## **WYANT LANDS MITIGATION SITE PHASE II – PROJECT EXPANSION**

Subject: DRAFT MY0/ As-Built Baseline Report & Record Drawing Review  
Wyant Lands: Phase II – Project Expansion  
Catawba River Basin: 03050102  
(03050103 Expanded Service Area)  
DMS Project ID No. 100595  
DEQ Contract #7244

RE: DRAFT MY0/ As-Built Baseline Report & Record Drawing Review  
Wyant Lands: Phase II – Project Expansion  
Catawba River Basin: 03050102  
(03050103 Expanded Service Area)  
DMS Project ID No. 100595  
DEQ Contract #7244

RE: Wyant Lands Phase II Project Expansion  
Lincoln County, NC  
Response to NCIRT Review Comments  
USACE Action ID No: SAW-2021-02449  
NCDMS Project No: 100595

Wyant Lands Mitigation Site Phase II - Project Expansion Record Drawing  
 Lincoln County, North Carolina  
 Wetland Grading Overview

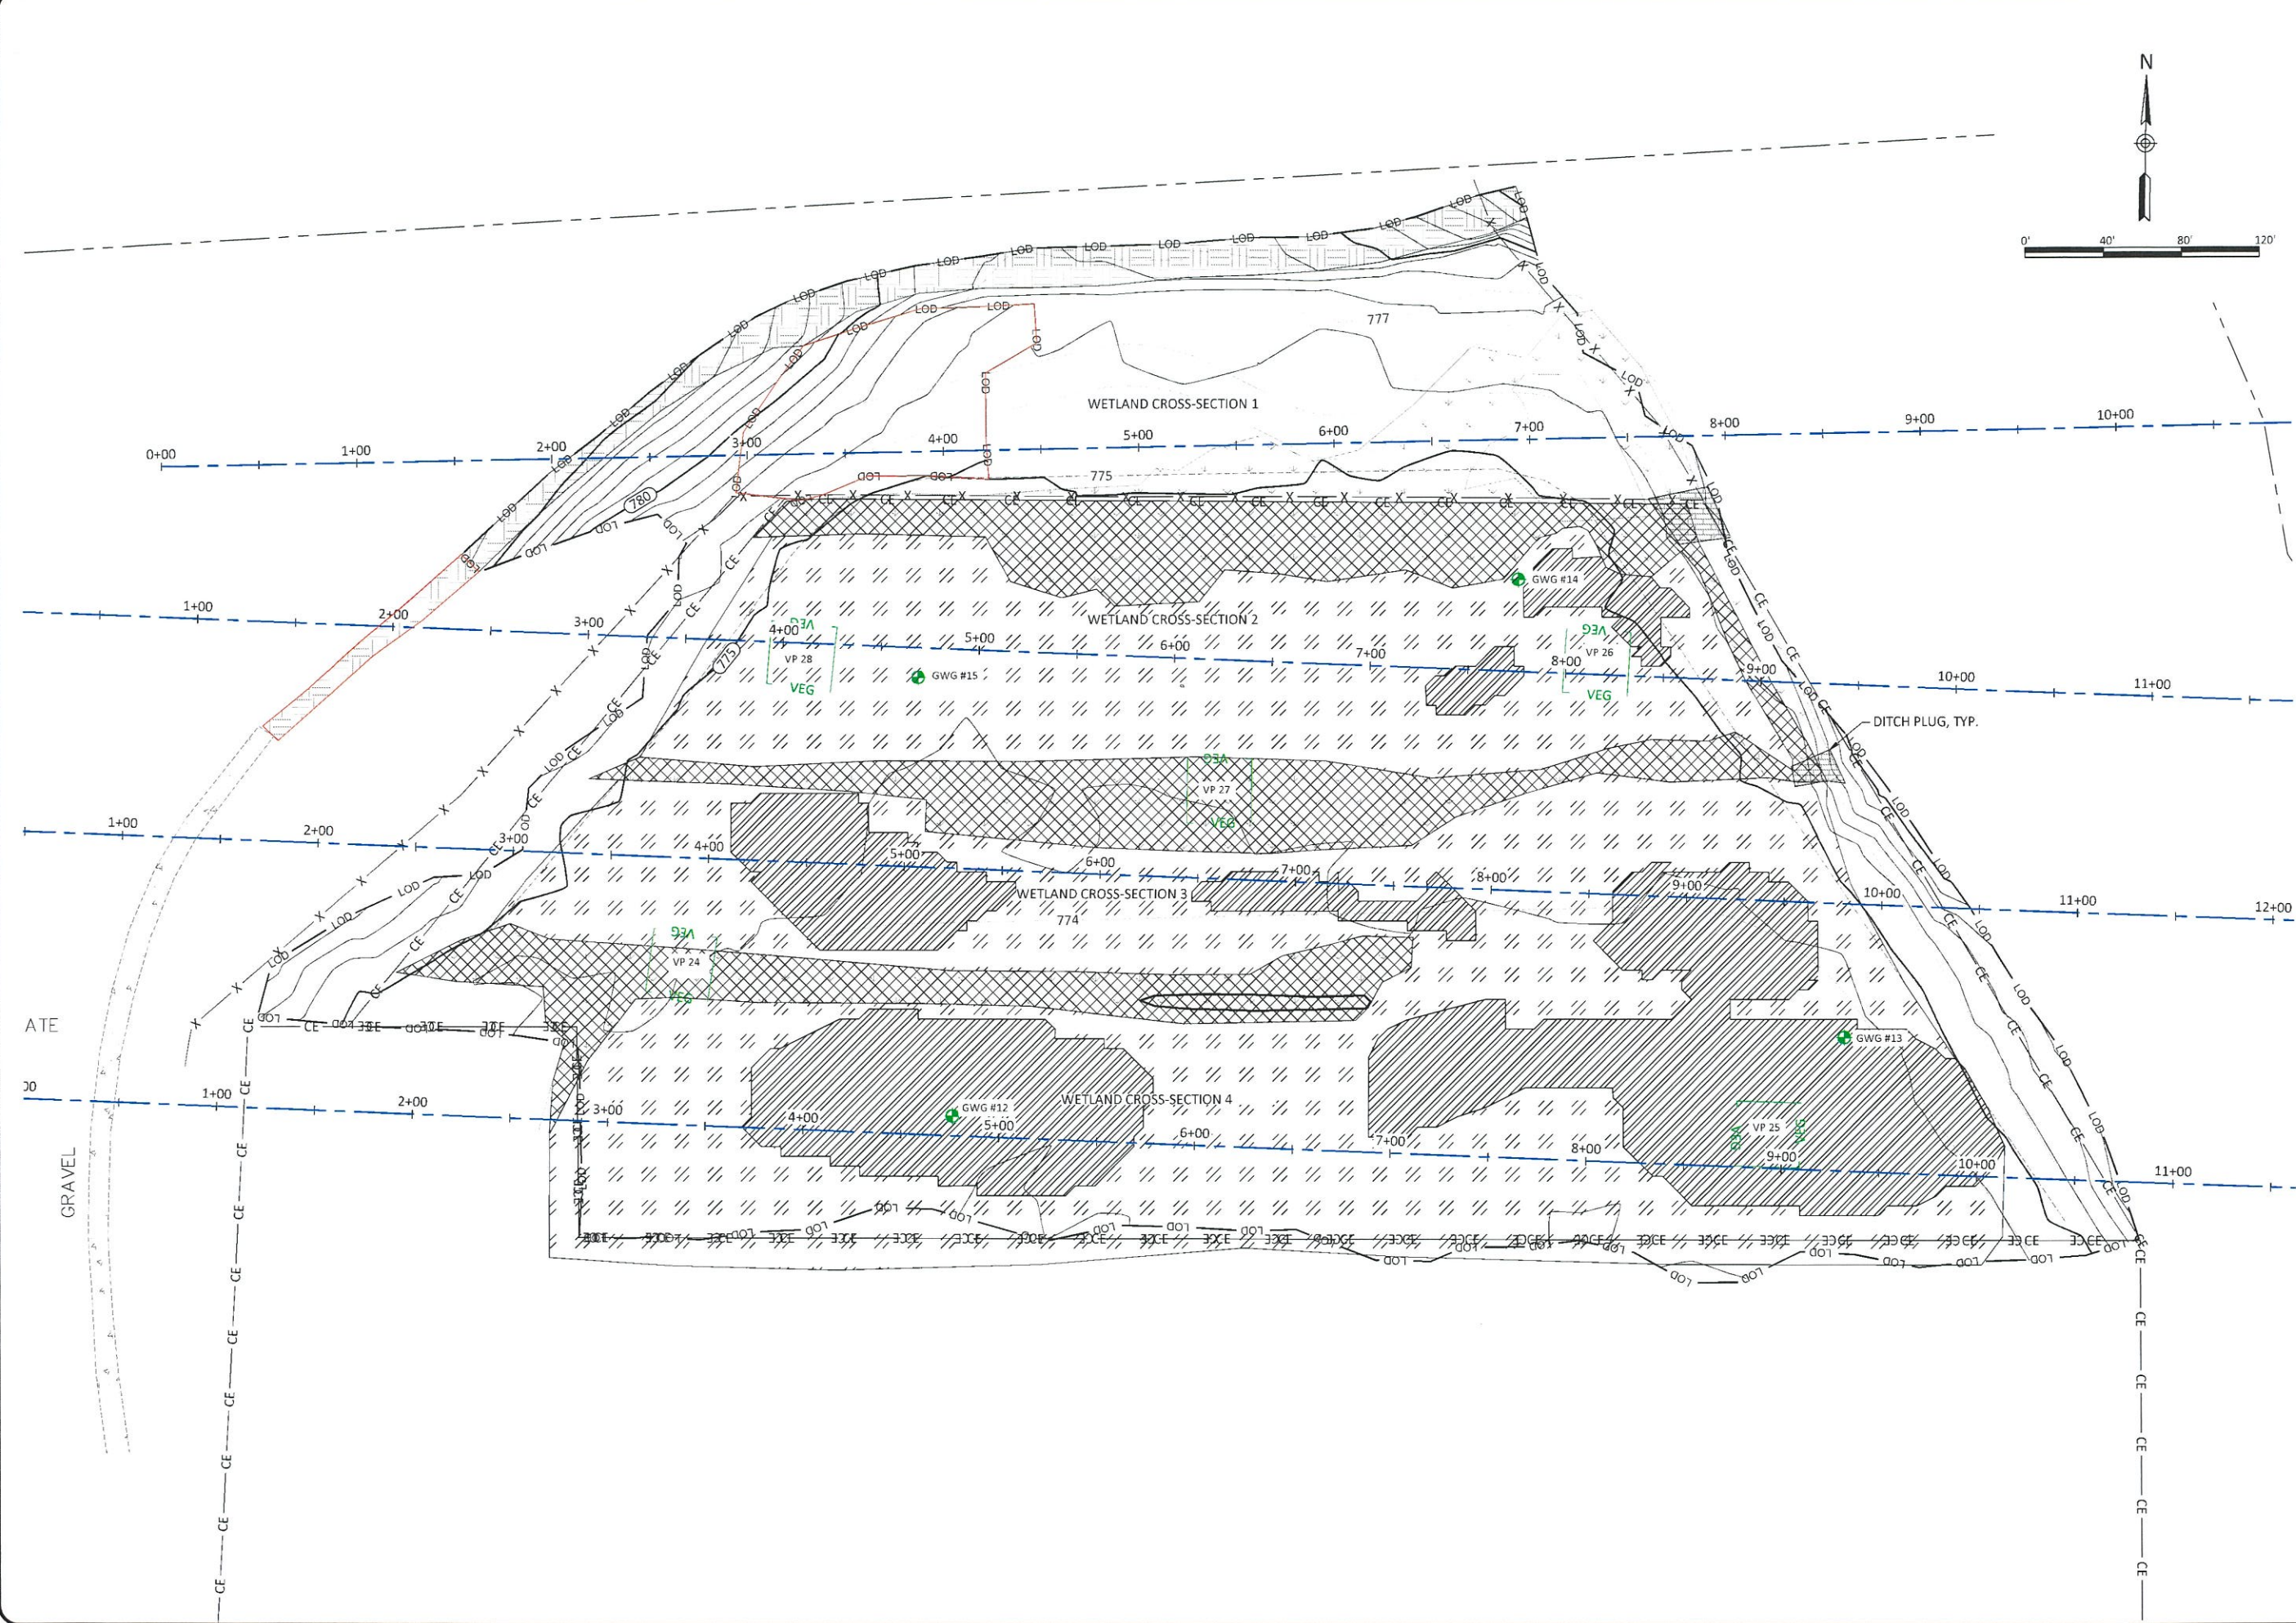
6. *Sheet 2.0 – With the grading proposed outside the easement, is it expected to result in a loss of any open water and/or wetland areas? It appears the Open Water 2 area will be graded up to elev. 777. Also, what is the minimum ditch plug length being proposed.*
